**WSCP A SUMMIT**

**Rho Max**

**March 3, 2002**

**Marina Del Rey  
Los Angeles  
California**

Figure 1 Shear Wall and Frame System

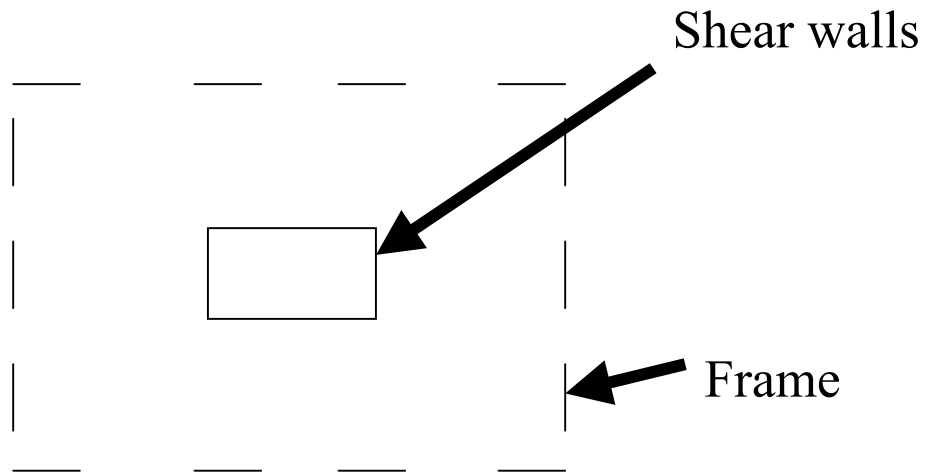
7. The 80% wall stiffness requirement of MSJC section 3.1.3.1 eliminates combined frame and shear wall building types allowed in other material systems.

*MSJC will review this restriction. The implications of the provision may not have been fully understood when originally written. Interpretation of the 80% stiffness is also unclear.*

Figure 2 Representation of the System Force Displacement Diagram

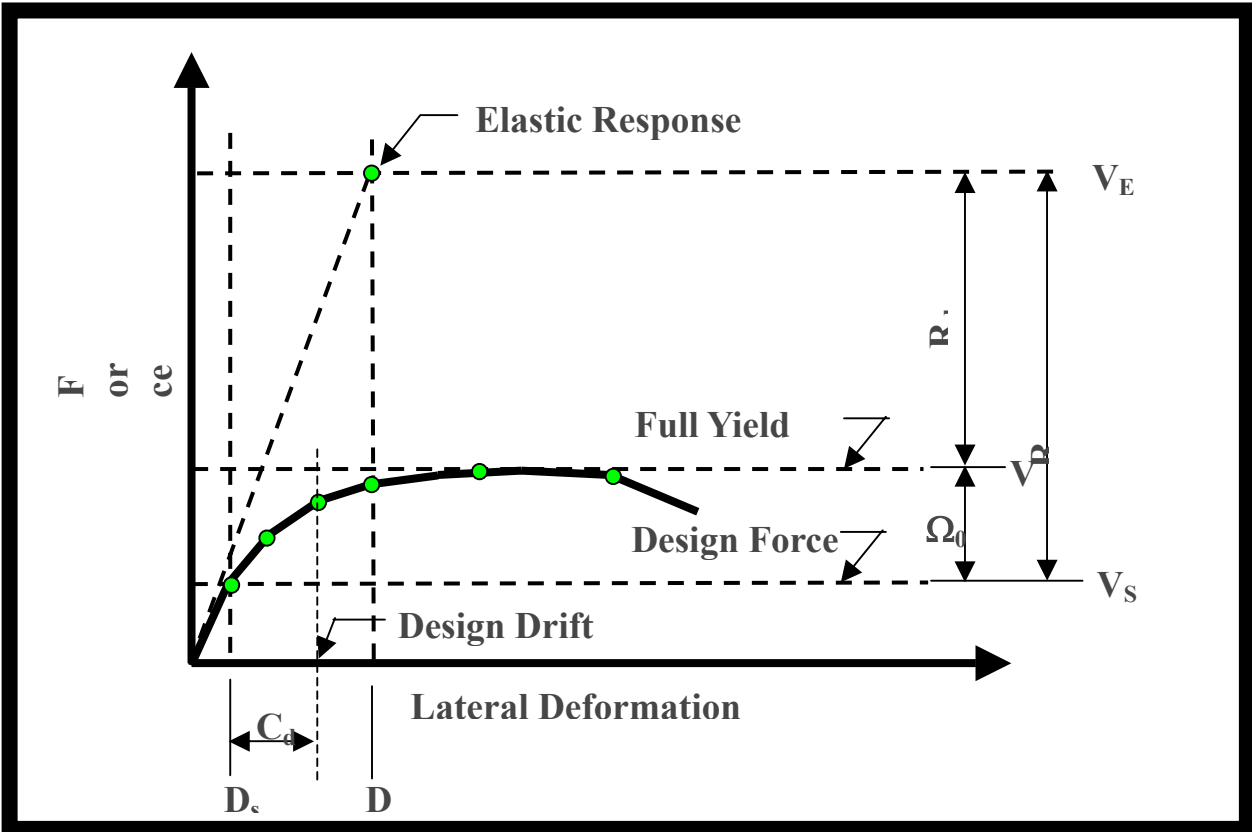
9. Does the 6 story RCJ hotel work with the  $R = 1.5$  option available?

*This was intended as the elastic response. But  $n = 2$  was still required and therefore requires considerable ductility. Discussion concluded that  $n$  should be a function of the system  $C_d$  instead of the system  $R$ . Actual inelastic drift demand will be a function of  $C_d$  times elastic drift. For a specific building, these may be*

*substantially less than those used to develop the current flexural ductility provisions.*

*If  $R = 1.5$  is  $\rho_{max}$  necessary. Consensus was no, but a possible over-strength factor might be required.*
